Expansion Project at North Point (EF III)

**SUPPLEMENT TO FINAL DEVELOPMENT  
PLAN APPLICATION**

24 July 2017

## **COMMENTS FROM PLANNING BOARD**

End of driveway enlargement

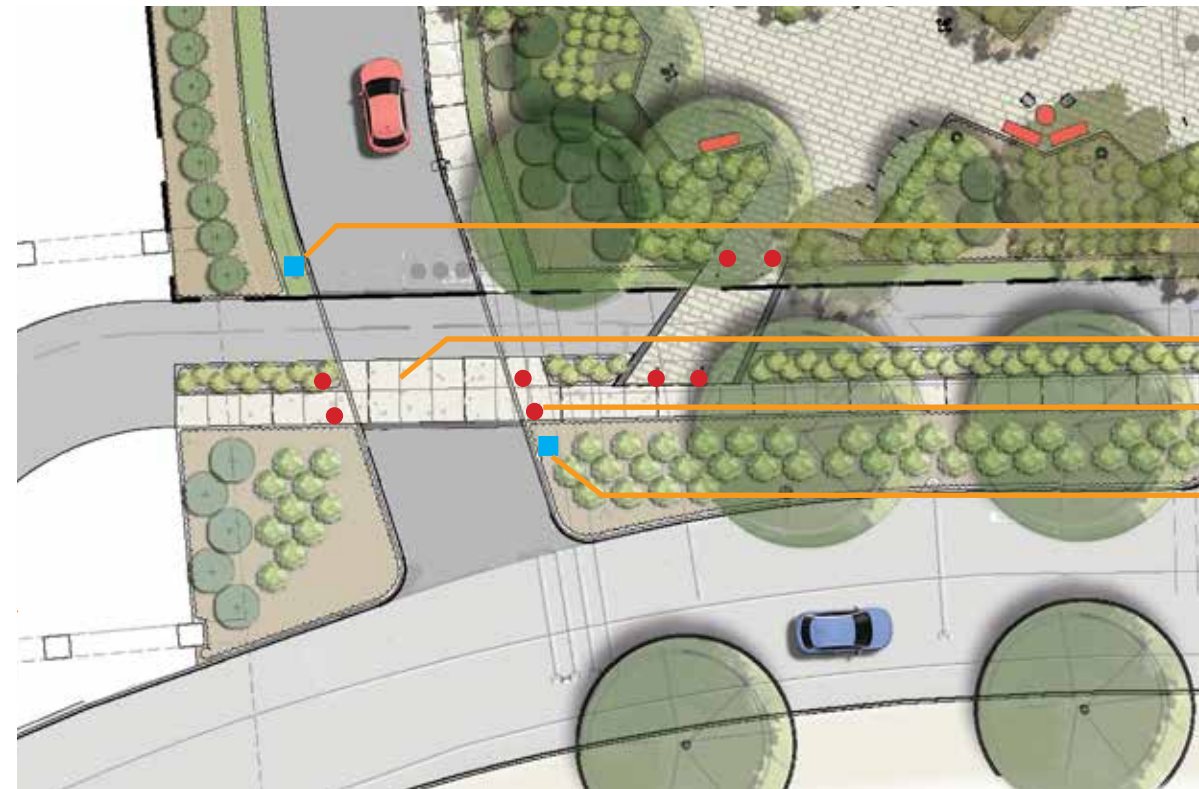
Consider potential conflicts between pedestrians accessing the building from the sidewalk and bicyclists on the multi-use path.

In order to reduce conflict between the pedestrians (and vehicles) exiting the building driveway and the bicyclists and pedestrians on the multi-use path, EF is proposing signage on either side of the driveway, a raised pavement treatment for the multi-use path over the driveway area, plus bollards on either end of the multi-use path.

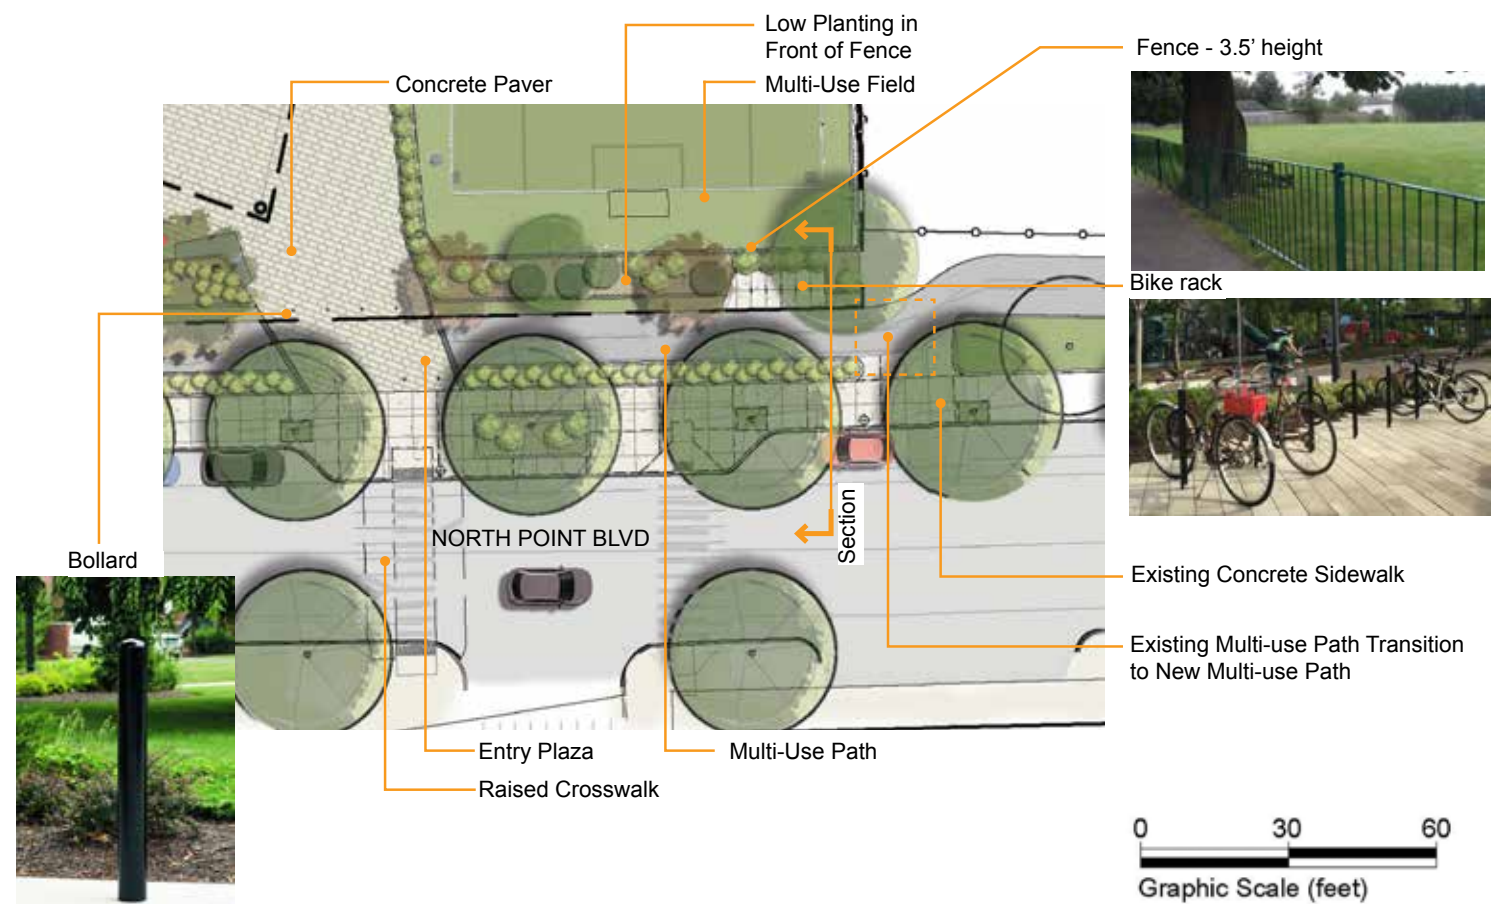
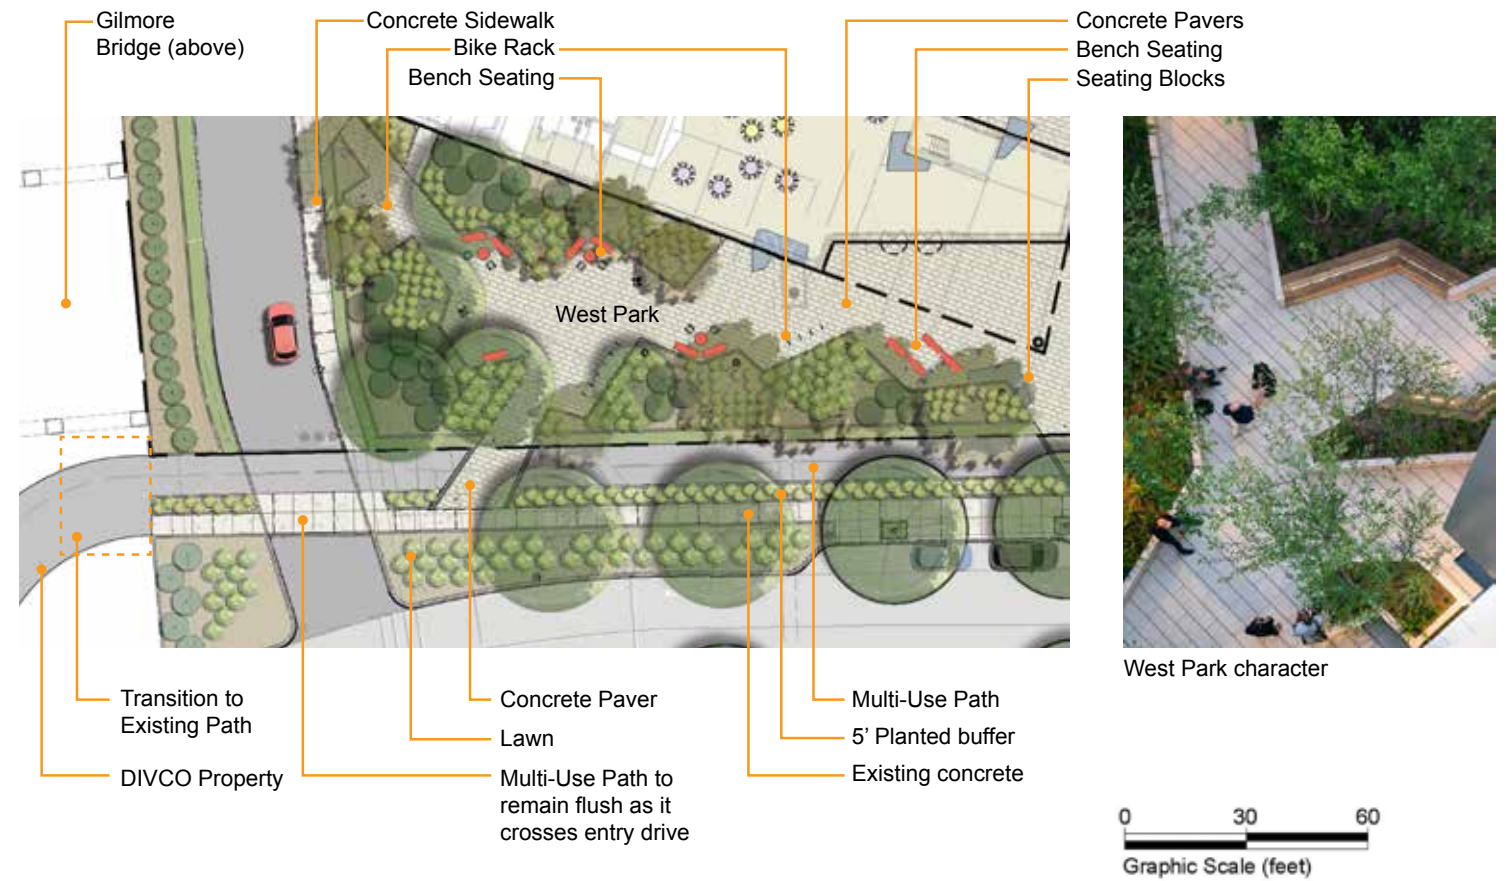
Provide details of all public realm and landscape treatments.

West Park occupies the area between North Point Boulevard and the proposed building, and is intended to serve as a gateway to the project from the Gilmore Bridge side. It will provide shaded passive recreational areas with benches, seating and bike parking, all available for public use. Signage will be displayed to inform the community of the public services available on the site and in the building.

Central Plaza occupies the area between the building and the multi-use field, and is entirely available for public use. Tables and benches are provided in this paved plaza, and shade will be provided by canopy tree plantings and a shade structure. Access to Central Plaza is provided by a paved walkway from the main building entrance area, and is accessible from the building.

Other landscape treatments include tree planting between the building and driveway to provide a green canopy along Gilmore Bridge, as well as a hedge along the property boundary adjacent to the Gilmore Bridge.

**1** Site Planting Plan  
Scale: 1"=20'

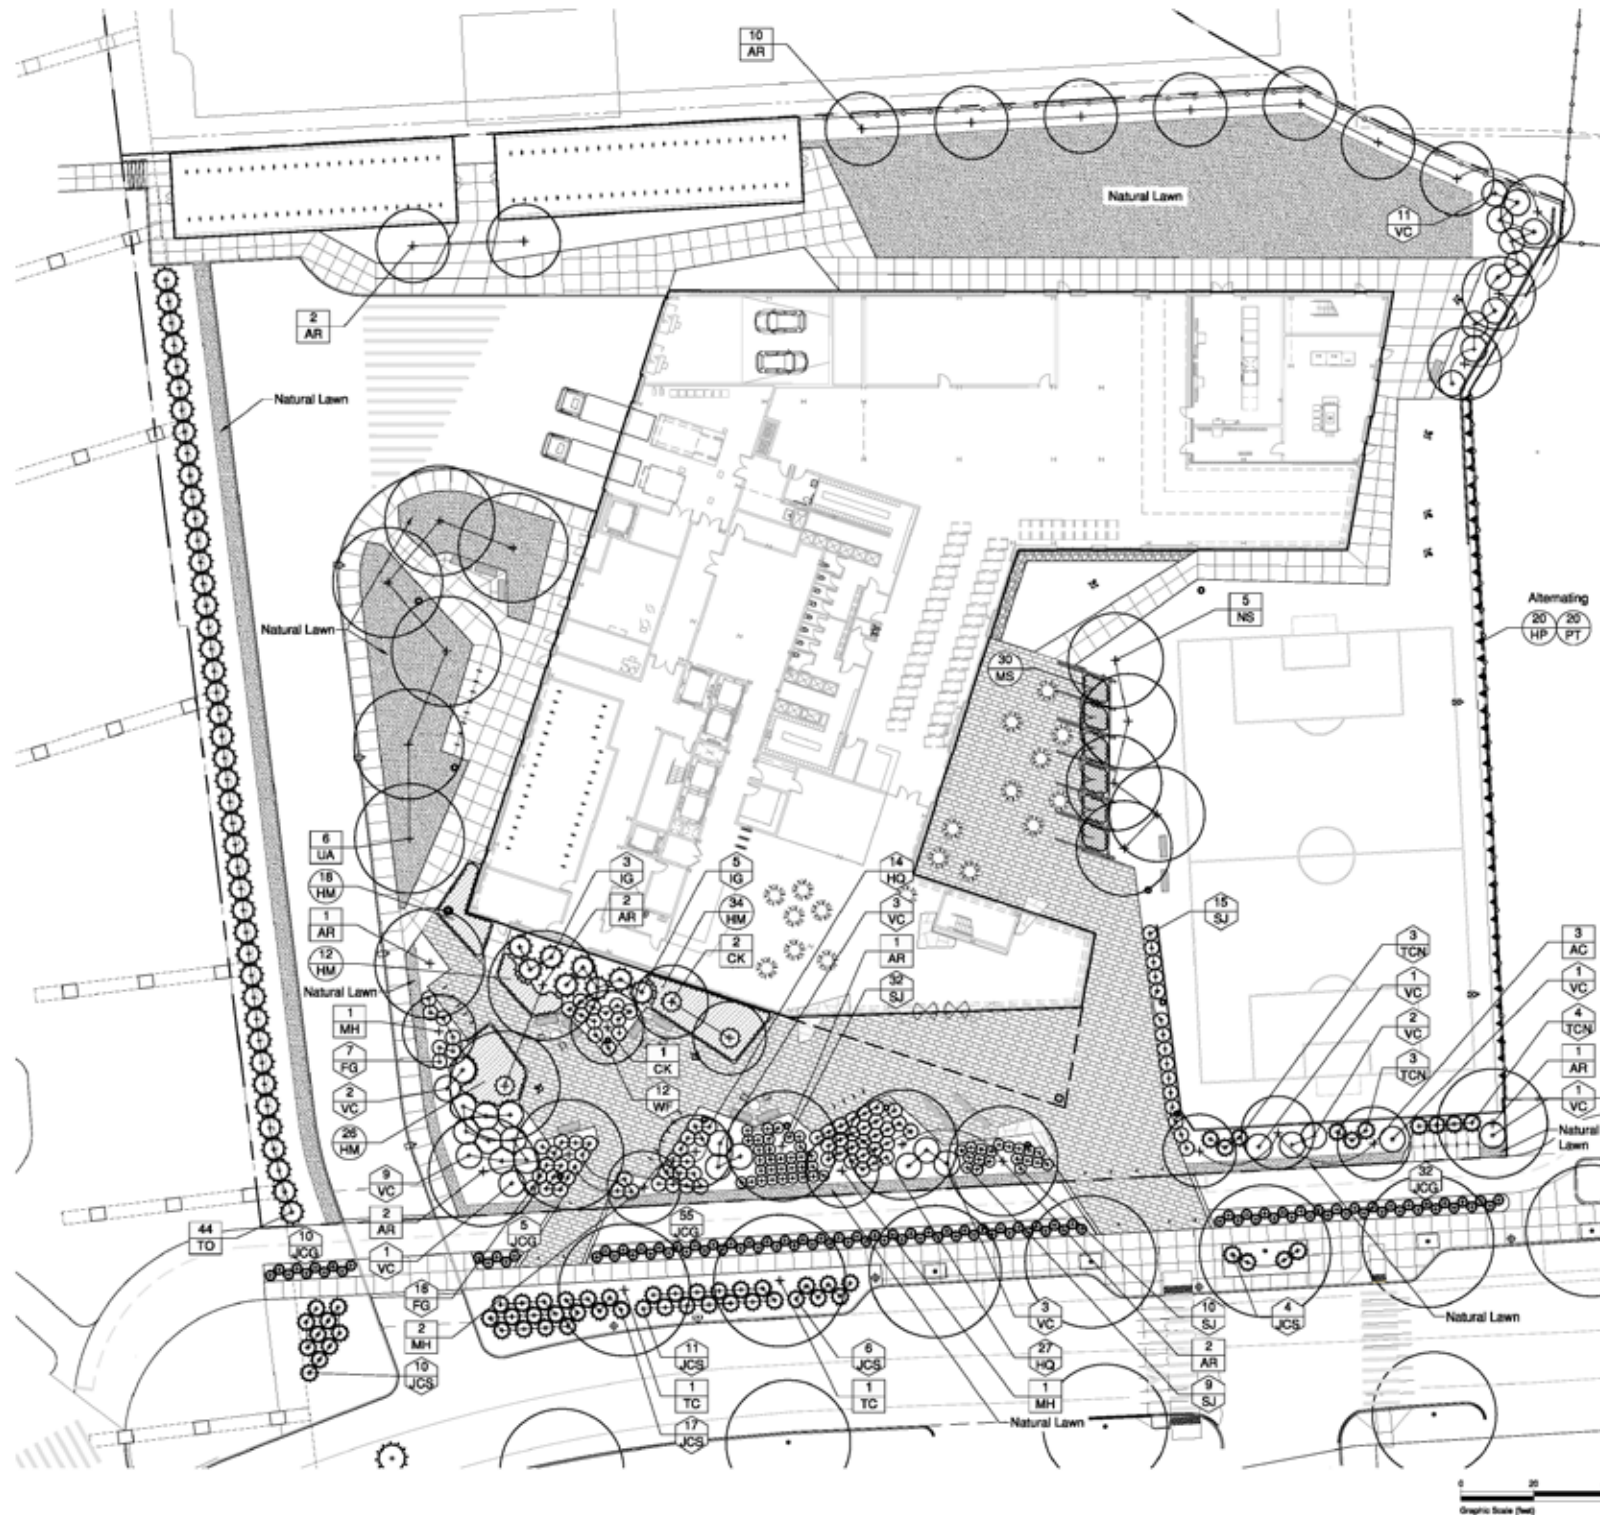
Provide details of all public realm and landscape treatments.

**Proposed Planting Plan** - EF proposes to plant in excess of 37 new shade trees with an installed total caliper of over 100" on the EF III site, along with another 7 understory trees with an installed total caliper of 20". The tree species will be selected from the list of recommended shade trees provided by the Committee on Public Planting. We intend to present the proposed Planting Plan for review by the Committee on Public Planting at the next scheduled hearing.
